Addendum

SPRINGS AT FREMAUX TOWN CENTER
SLIDELL, LA

PHILLIPS JOB NUMBER 1333104
ISSUE DATE 07/07/14
DRAWN BY/CHECKED BY ATL/DEB
DRAWING TITLE UNIT 2GC FLOOR PLAN, ELEVATIONS & DTLs.
SHEET NUMBER A4.2GC

UNIT 3GC
FLOOR PLAN,
ELEVATIONS & DTLs.
 SHEET NUMBER

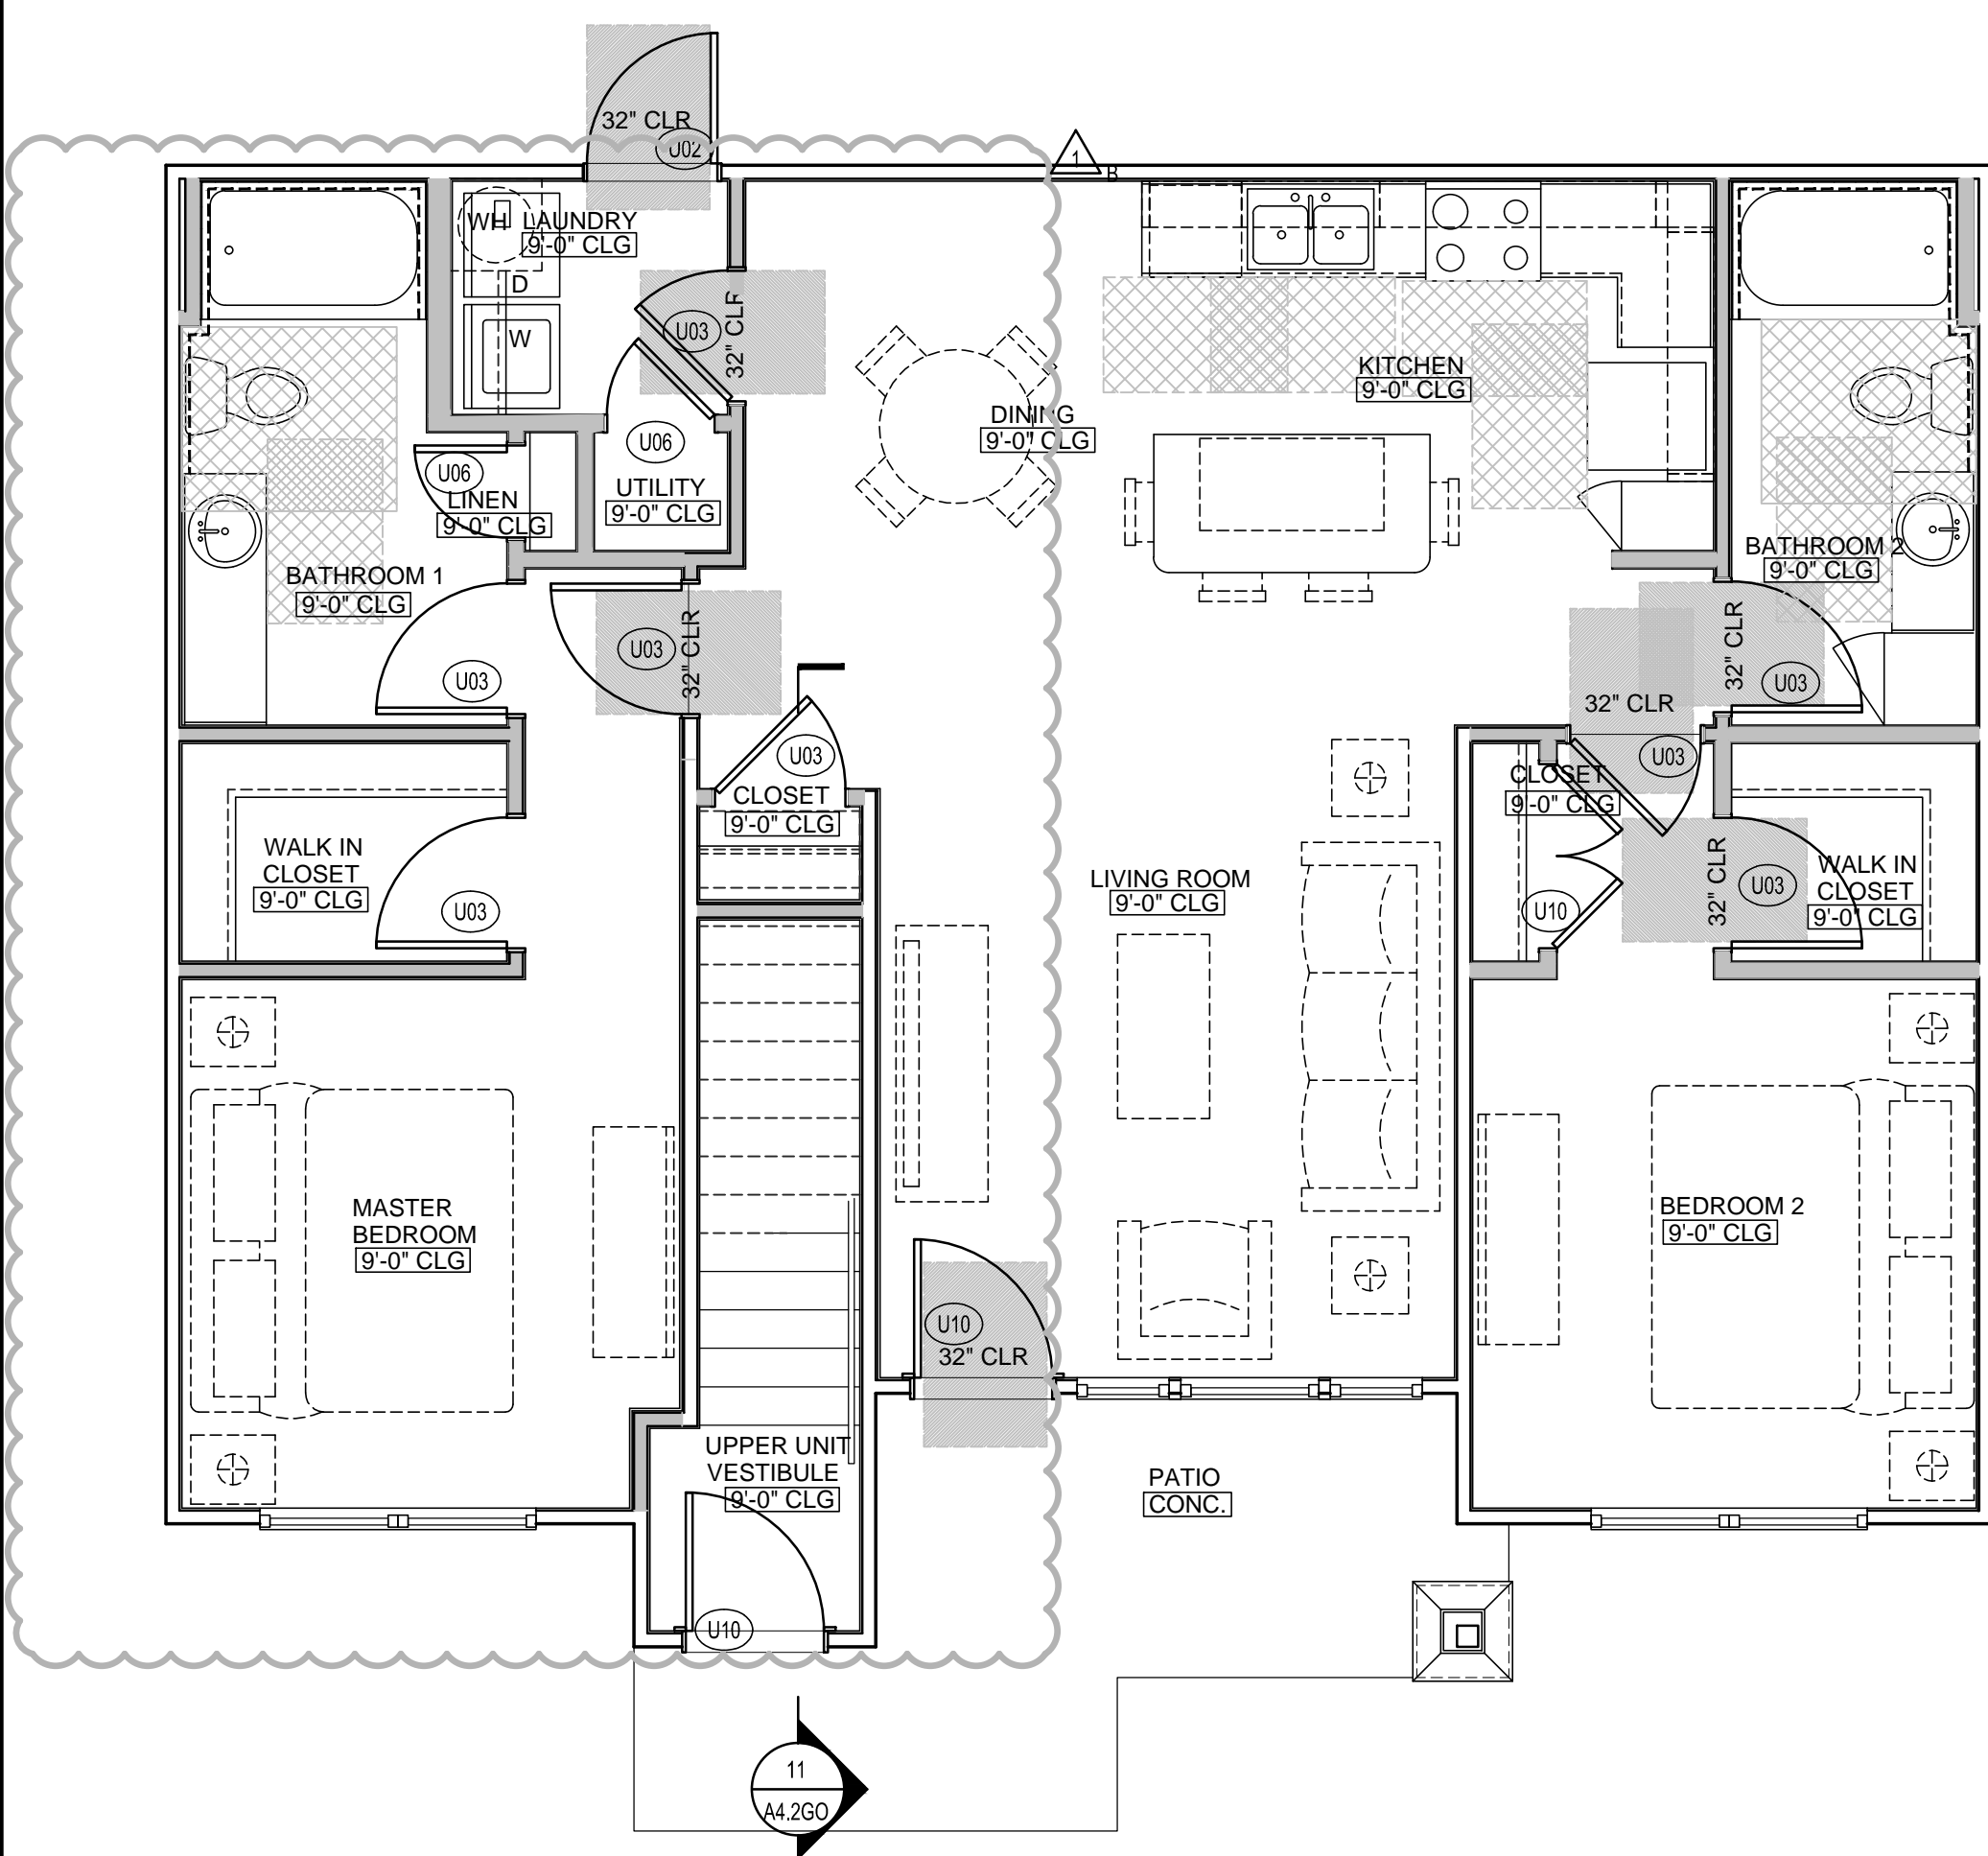
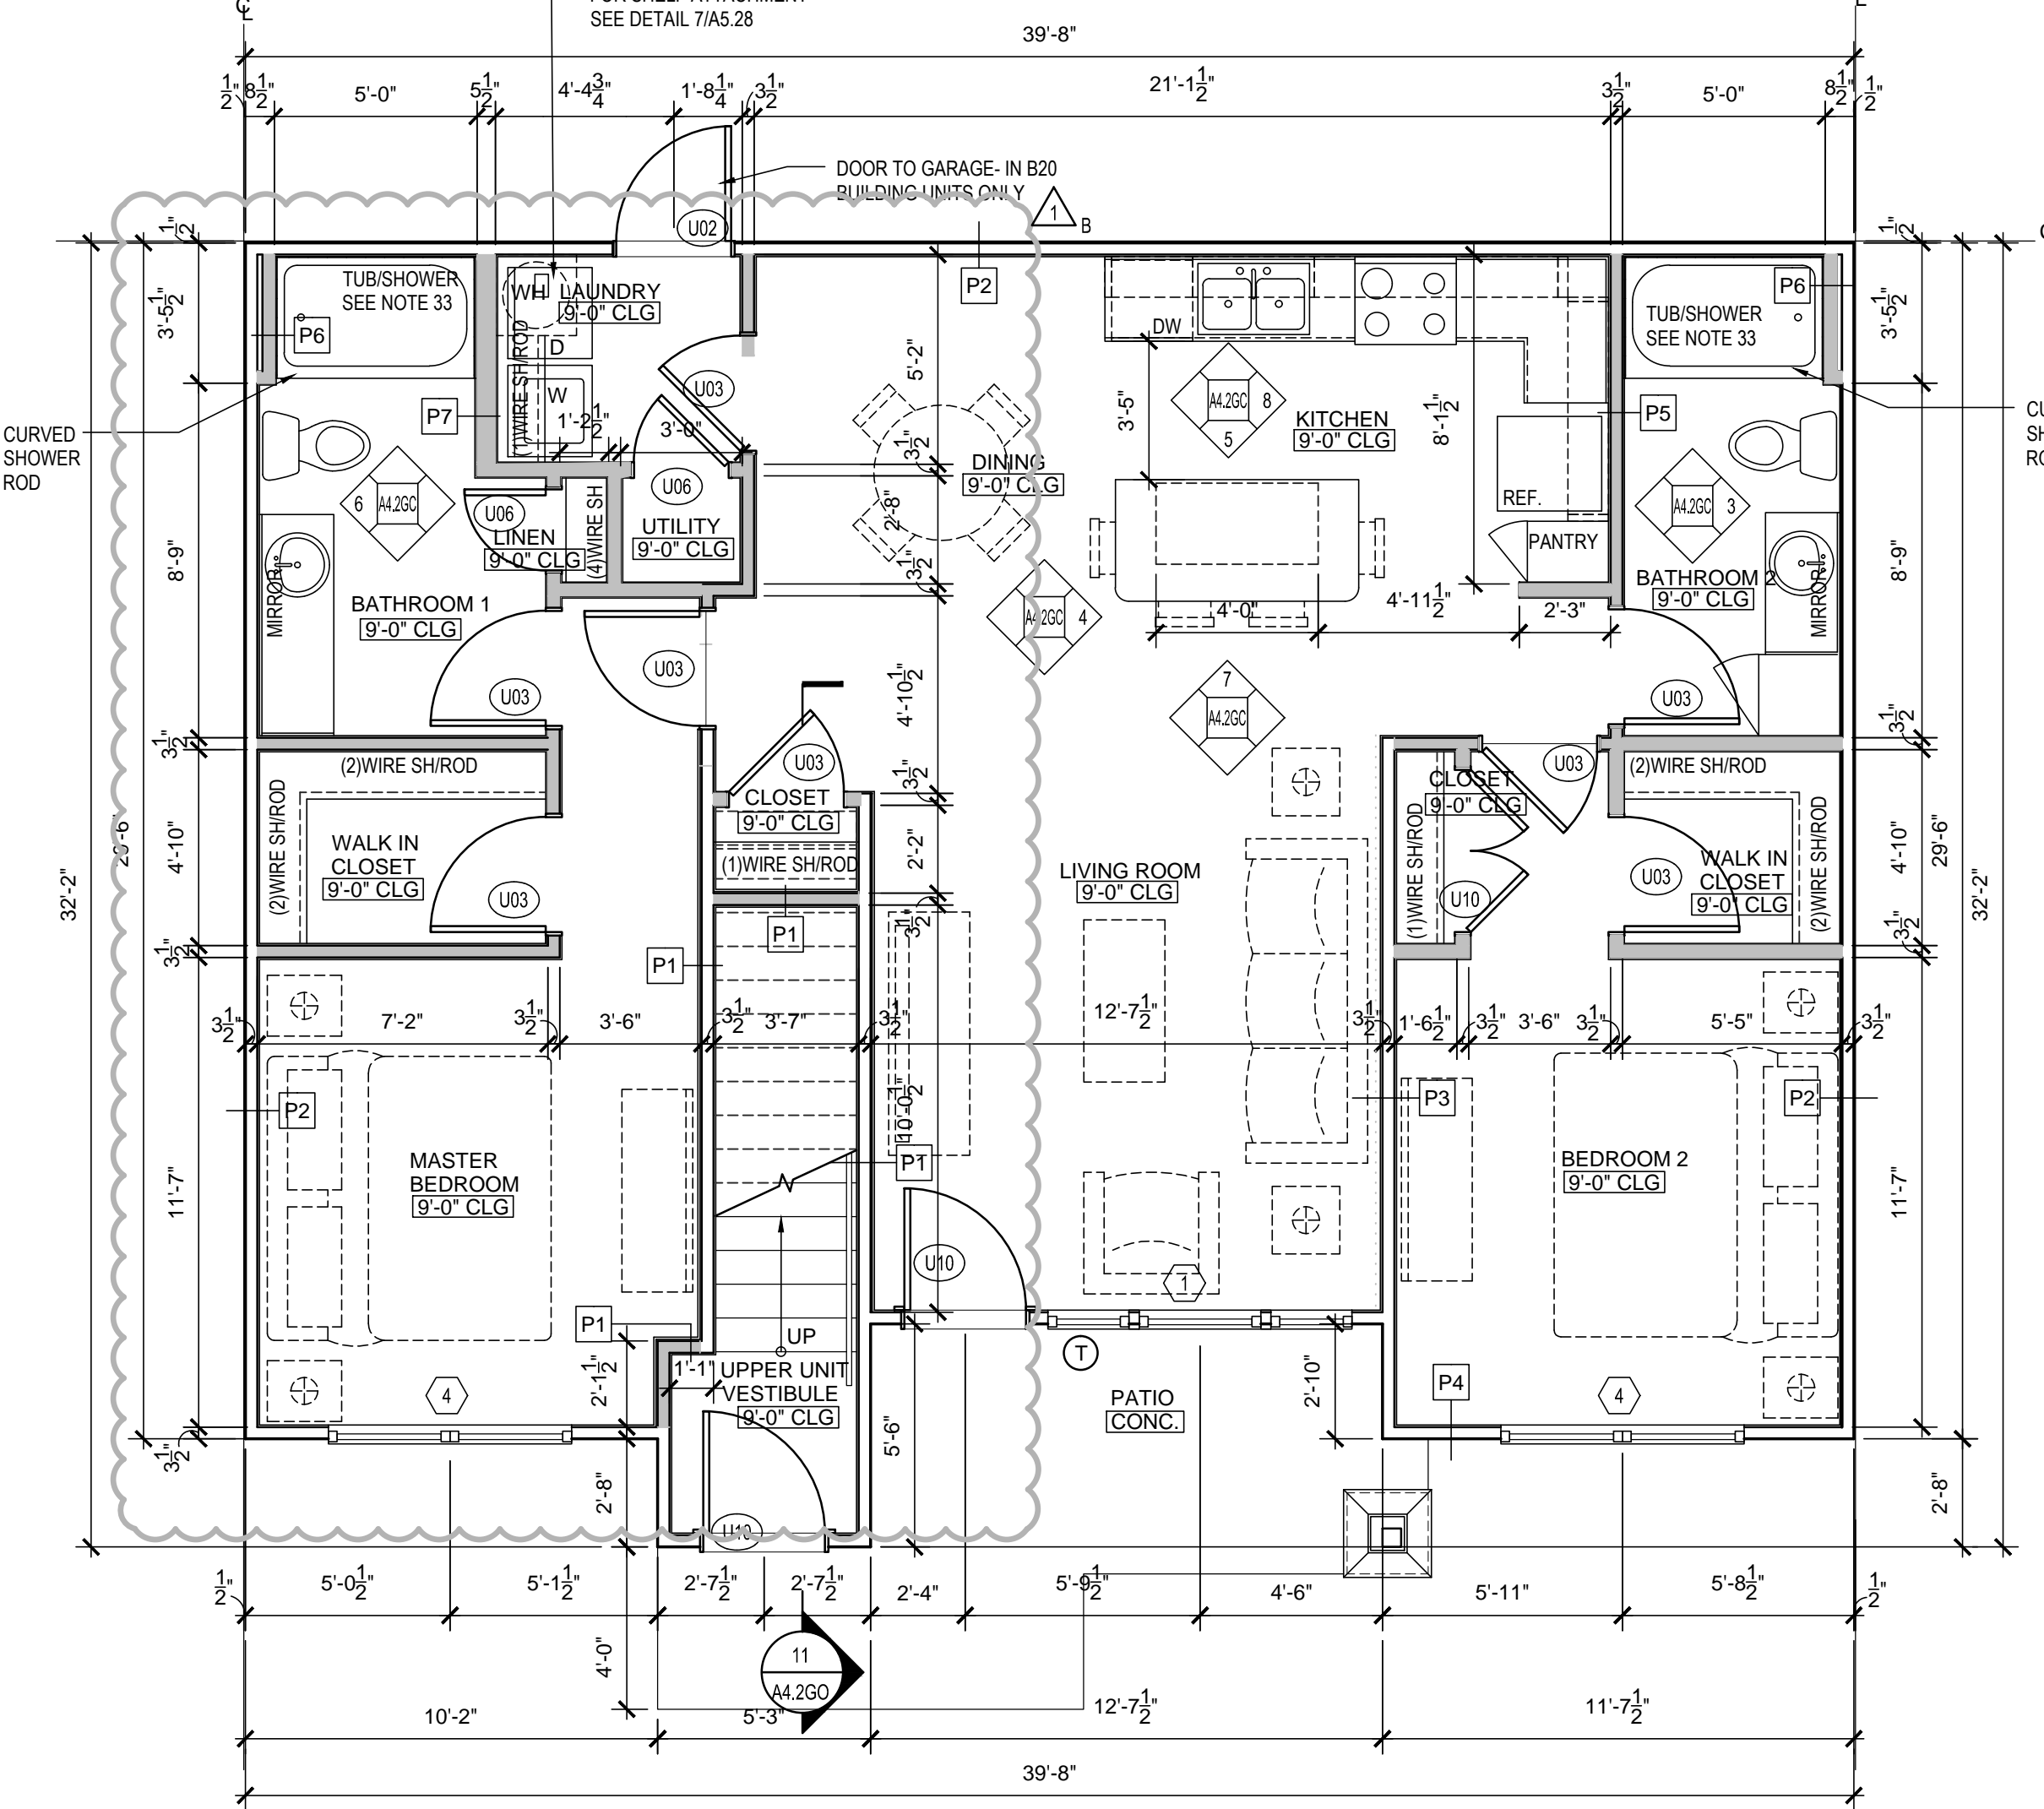
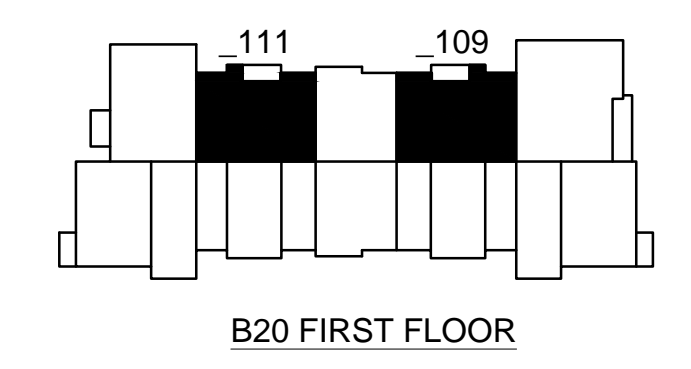
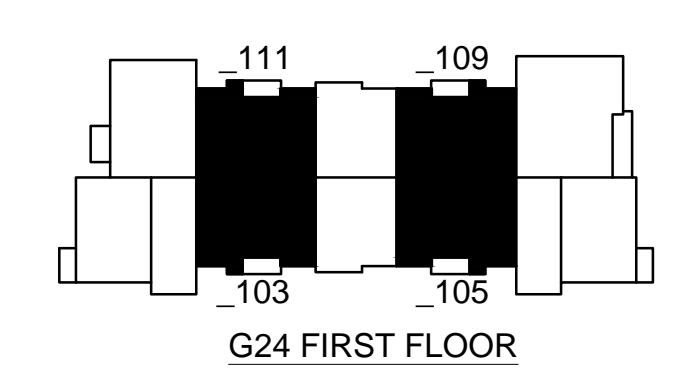
- REVISION #1 SUMMARY**
- REMOVED TILE BACKSPLASH AT CONCERGE UNITS
 - UPDATED UNIT PLAN TO SHOW REVISED CLOSET, BEDROOM, AND BATHROOM LAYOUT
 - UPDATED BATHROOM ELEVATION TO COORDINATE WITH UNIT PLAN
